Addendum No. 1
March 3, 2025

Project: Reroof Damaged Areas
South Dakota State University Student Union
Brookings, South Dakota
SDSU Project# 25-154440
OSE Project #R0325--12X/DEL
Architecture Incorporated Project #3099

Architect: Architecture Incorporated

ROOF DEMOLITION PLAN

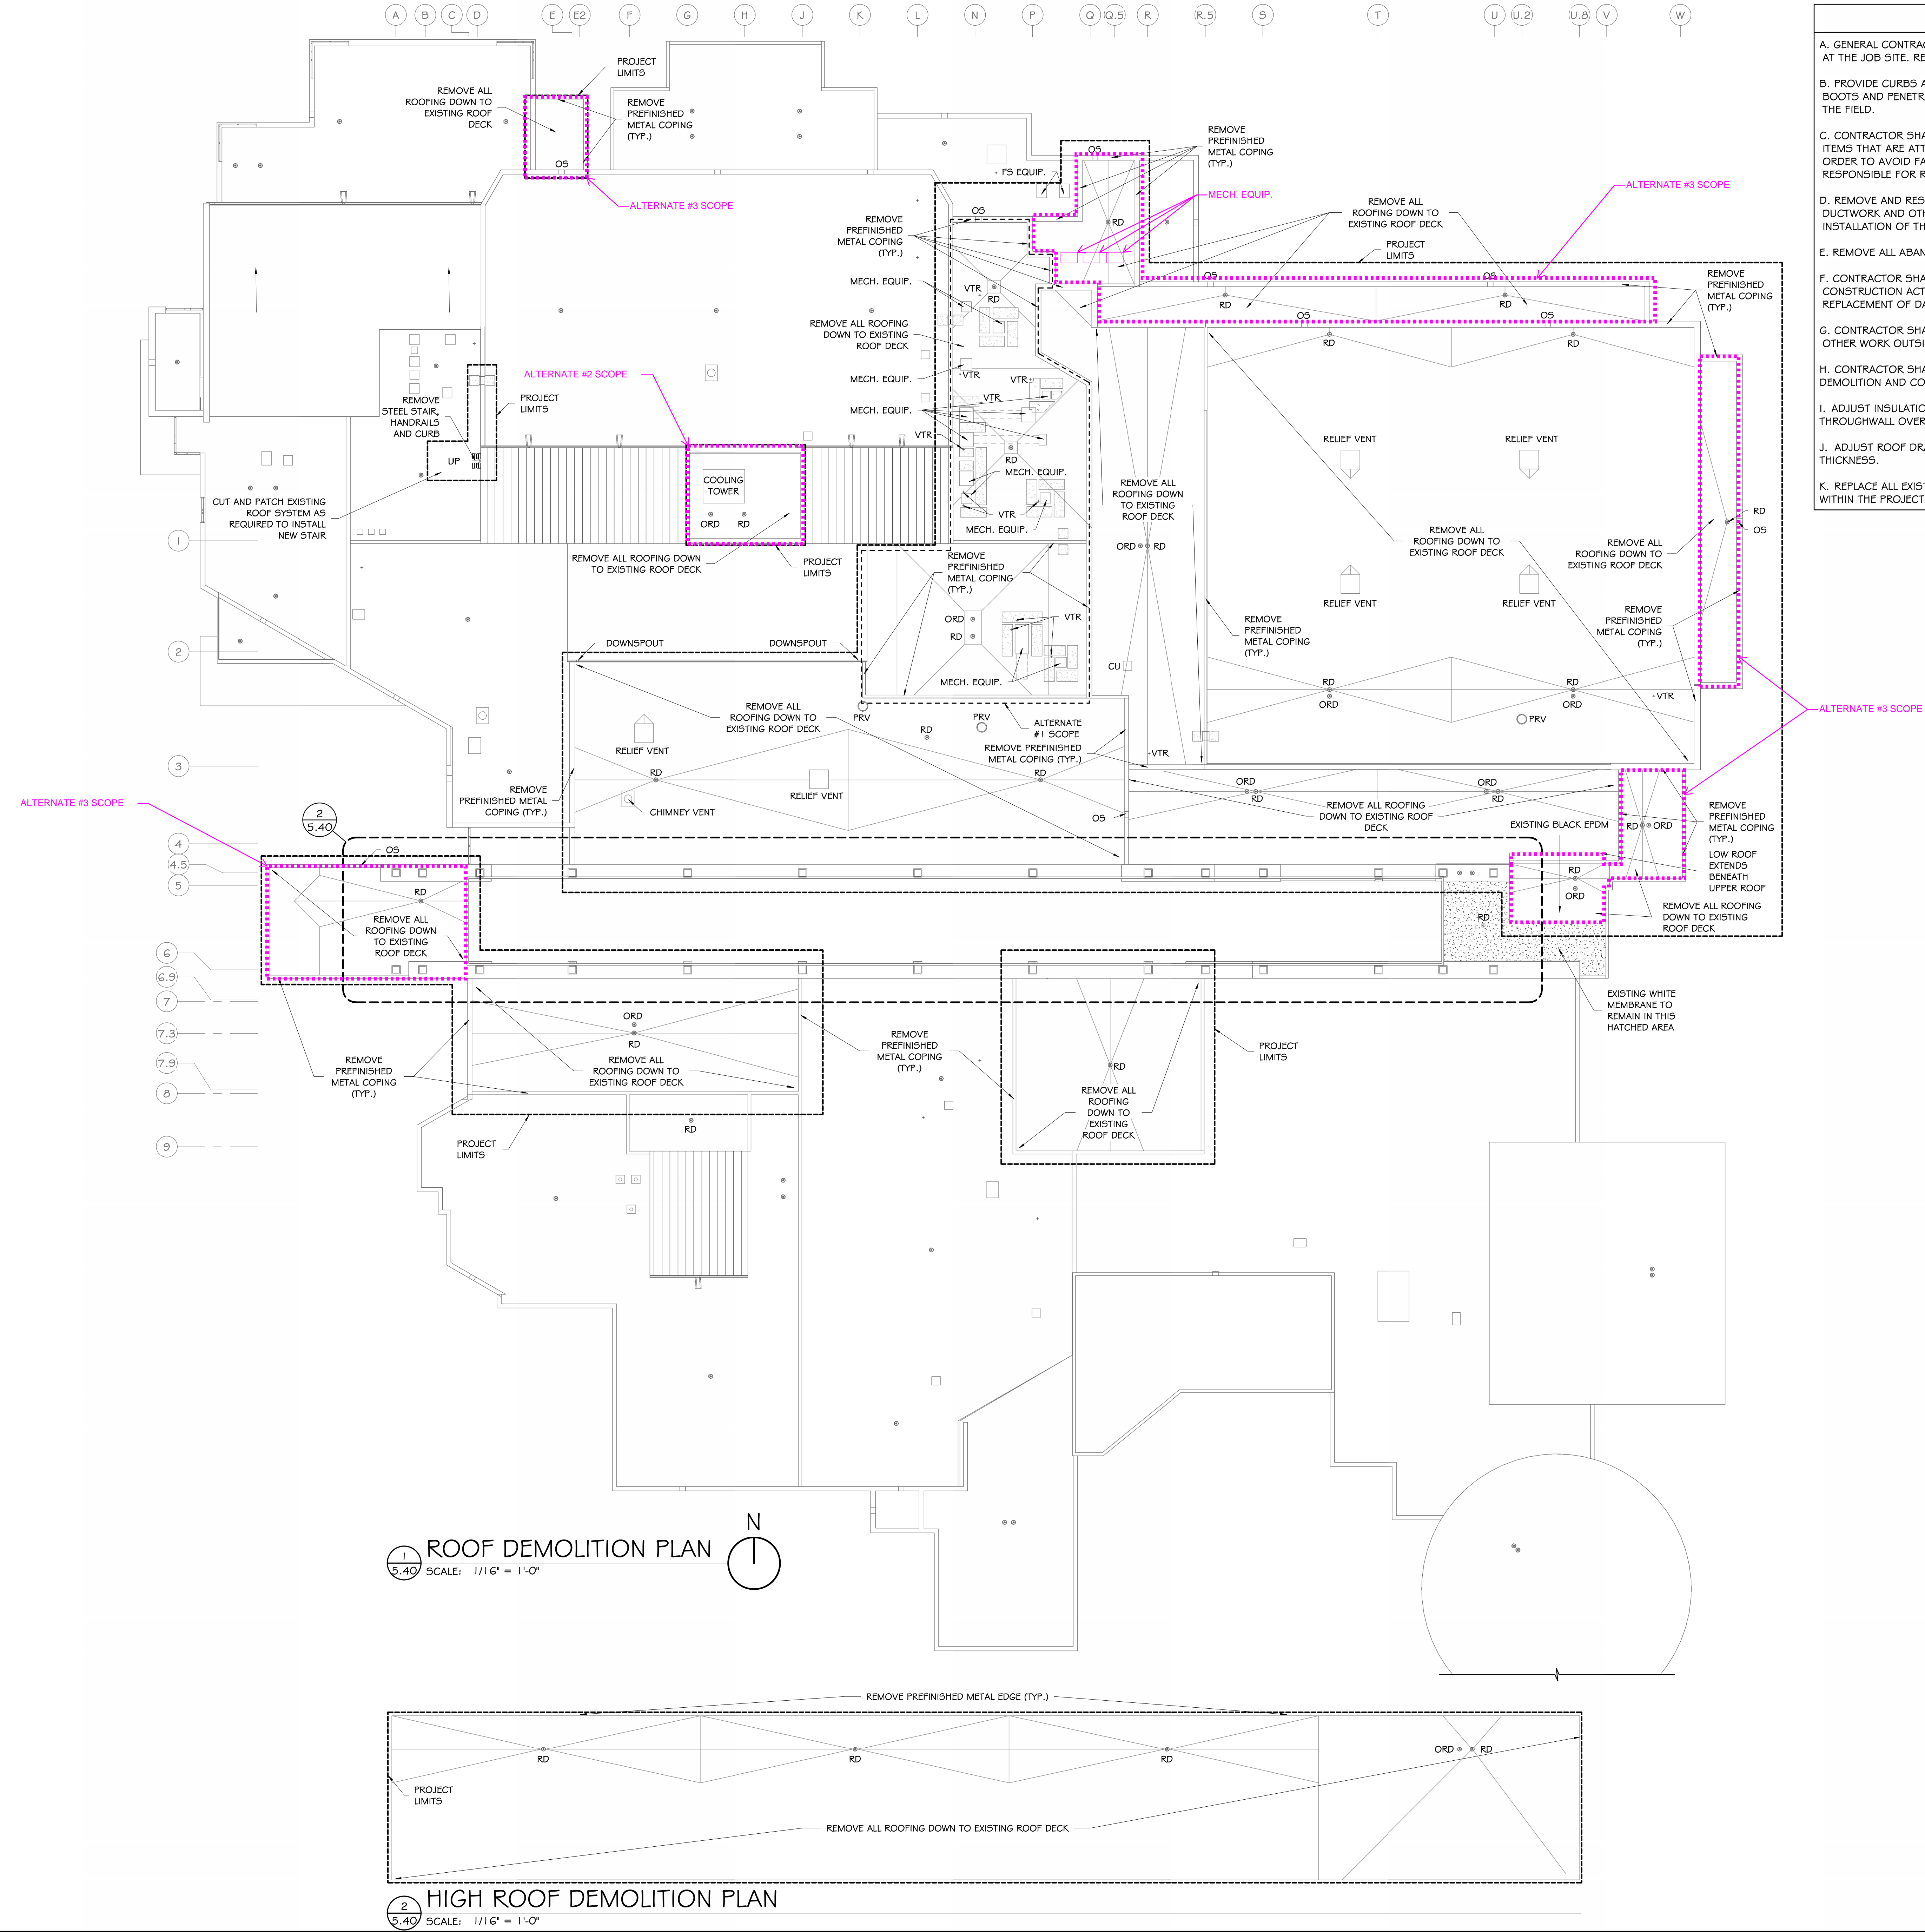
4) DRAWING SHEET 5.40 – ROOF DEMOLITION PLAN

- a) Reference attached revised Drawing Sheet 5.40 for the following:
 - i) Base bid scope that has been changed to Alternate #2 and Alternate #3 scope.
 - ii) Added existing rooftop mechanical equipment at north side of the building.
